NOVA-NEAR_DETECTOR
MUON CATCHER/PANCAKE CYLS CRADLE
BOTTOM PLATE

SCALE	DRAWING NUMBER	SHEET	REV
1:2	3929.330-MB-489938	1 OF 1	A

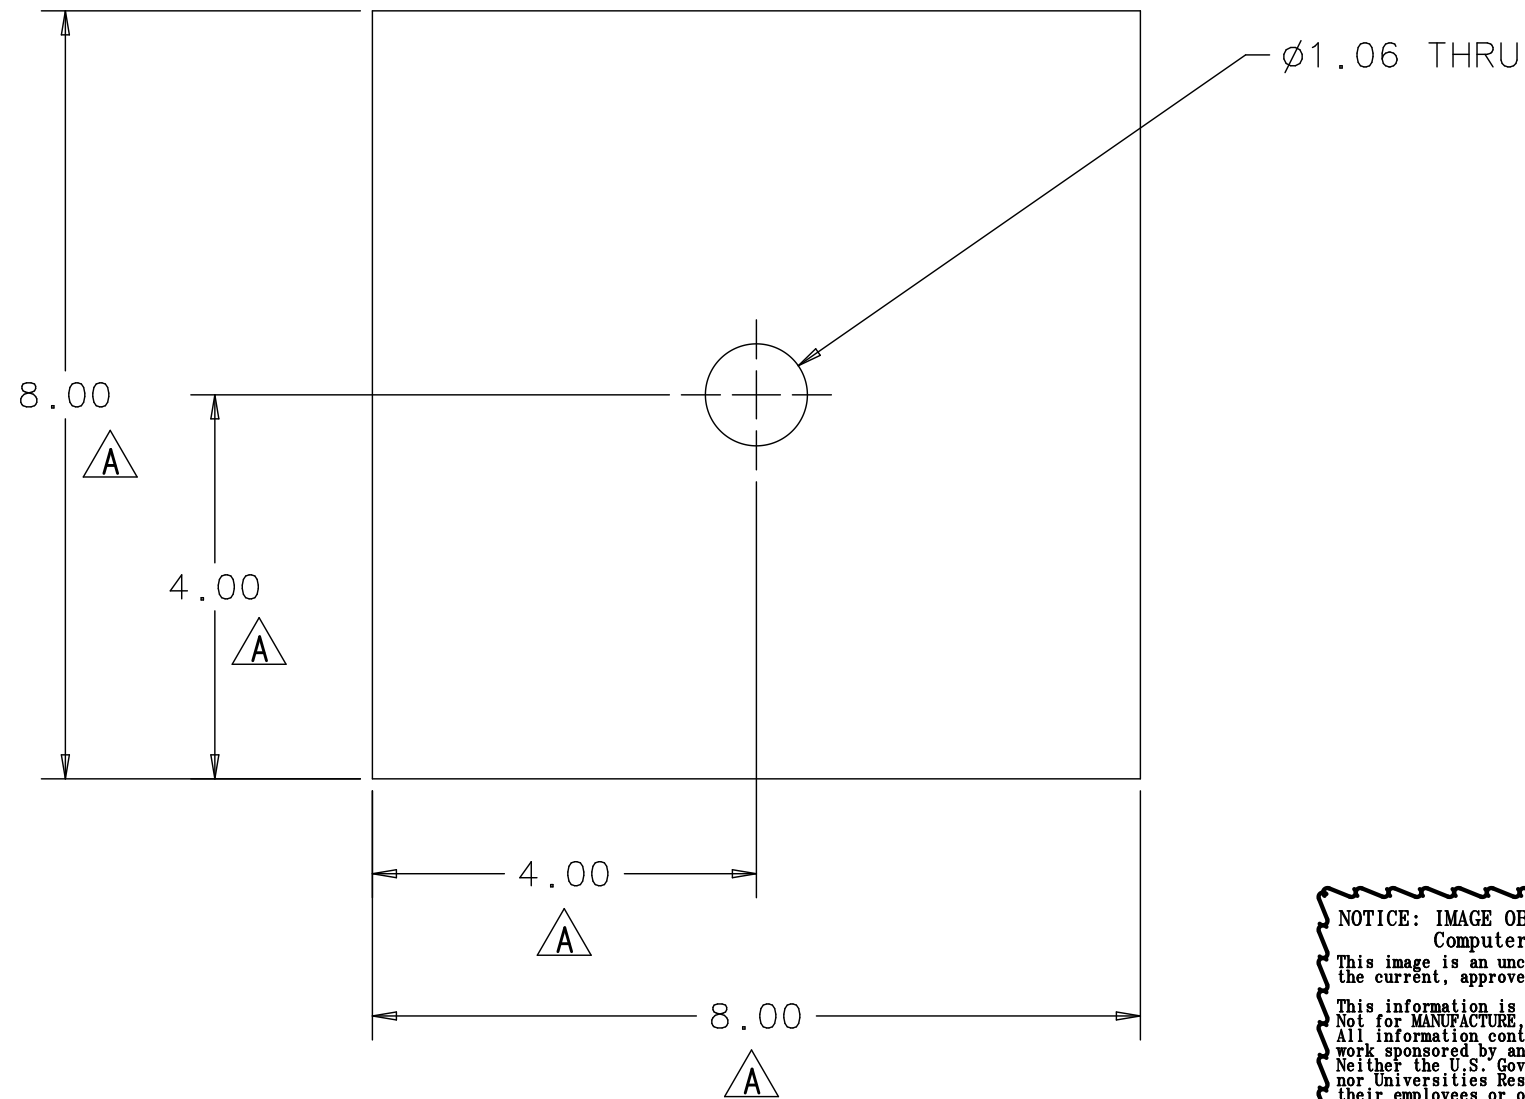
REV	DESCRIPTION	DRAWN	DATE
		APPROVED	DATE
A	PLATE WAS 6.50 X 6.50 NOW 8.00 X 8.00 WEIGHT WAS 5.8 LBS. NOW 9 LBS	G SMITH	30-MAY-2013
		D FRIEND/EMV	30-MAY-2013
